August 24, 2018

Subject: Fuel Leak Case No. RO0002931 and GeoTracker Global ID T0600174667, Shore Acres Gas, 403 E. 12th St., Oakland, CA 94606

TECHNICAL COMMENTS - FIRST WORK PLAN ADDENDUM AND SITE CONCEPTUAL MODEL

PROPOSED SOIL VAPOR PROBE
CONSTRUCTION DETAIL

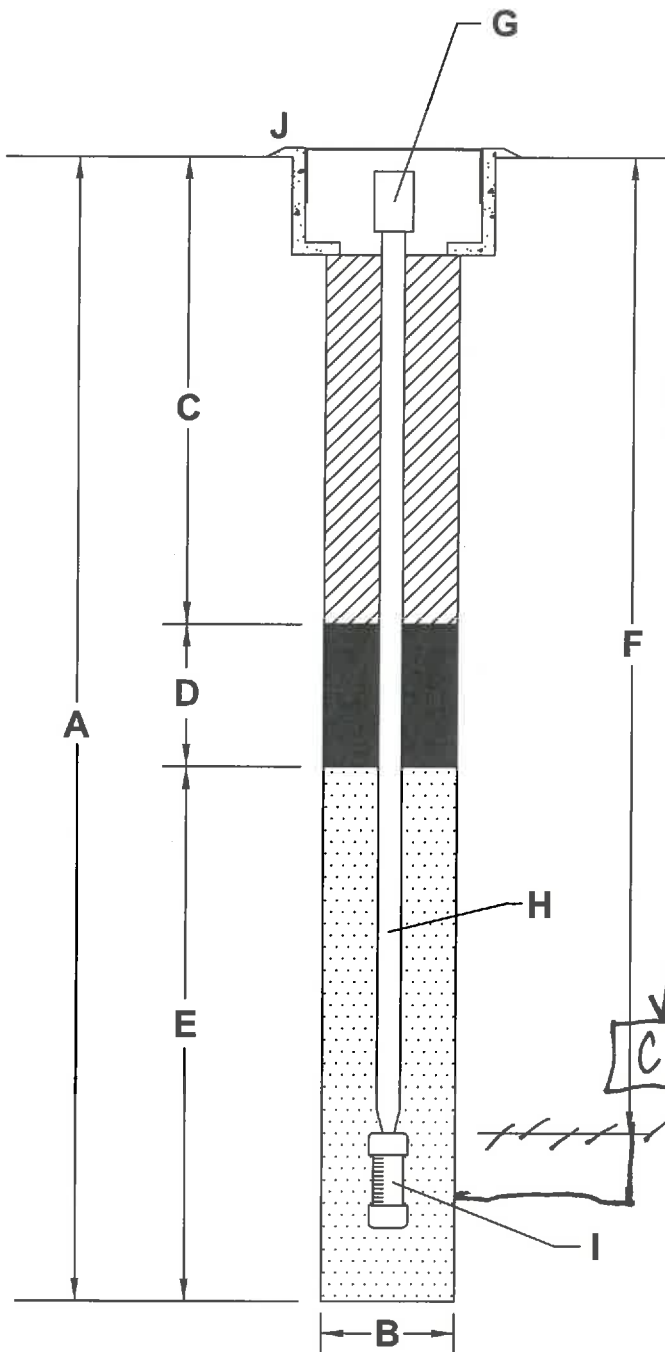
- 2. Installation Depth of Soil Vapor Probe:** According to the LTCP, soil vapor samples must be collected from a depth of 5 feet bgs which must consider the thickness of the concrete slab or asphalt surface, assumed to be approximately 6-inches thick. Please install each soil vapor probe to a depth of 5.5 feet below ground surface (bgs) to and immediately adjacent to offsite buildings.

- 3. Installation Construction of Soil Vapor Probe:** Please see the Attachment 2, ACDEH's required revisions for soil vapor probe construction. This request is based on DTSC Vapor Guidance documents.

- 7. Soil Vapor Analysis by TO15 and TO17:** The Work Plan describes using nylon or Teflon tubing in the construction of the soil vapor probes. Because naphthalene readily sorbs onto traditional soil gas tubing such as polyethylene and nylaflow as described in DTSC's *Advisory Active Soil Gas Investigations* (July 2015) Appendix E, ACDEH requests analysis of all soil gas samples for TO-15 full scan volatile organic compounds (VOCs) and naphthalene confirmation analysis using EPA Method TO-17 analysis for all soil vapor samples because TO-17 will detect constituents with low vapor pressure, including naphthalene, whereas TO-15 does not readily detect constituents with low vapor pressure, including naphthalene, as described in DTSC's *Advisory Active Soil Gas Investigations* (July 2015) Appendix E.

C Sanitary Seal From 0 to * 3.5 ft.
Seal Material Hydrated Granular Bentonite *see below*

D Seal From * 3.5 to * 4.5 ft.
Seal Material Dry Granular Bentonite

E Filter Pack From 4.5 to * 5.5 ft.
Pack Material No. 3 Lonestar Sand

H 1/8" To 1/4" Tubing *specify material*

C. Seal Material = Neat cement grout w/ up to 5% bentonite powder
